Proposed changes to support Management VID TLV

Figure F-6 – Management VID

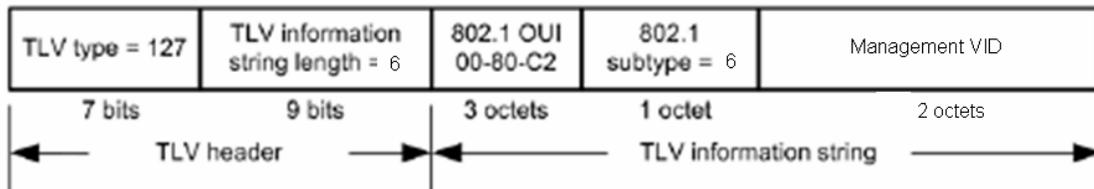
(page 126 [144], line 41) Insert subclause F.7 similar to section F.2 but describing the Management VID TLV instead of the Port VLAN ID TLV, and appropriately renumbering the current clauses F.6 to F.8 and their subclauses:

F.7 Management VID TLV

The Management VID TLV is an optional TLV that allows an IEEE 802.1Q-compatible IEEE 802 LAN station to advertise the value of a Management VID associated with the system.

Figure F-6 shows the Management VID TLV format.

F.6.1 Management VID

The Management VID field shall contain the value configured for the Management VID or the value 0 if a Management VID has not been provisioned.
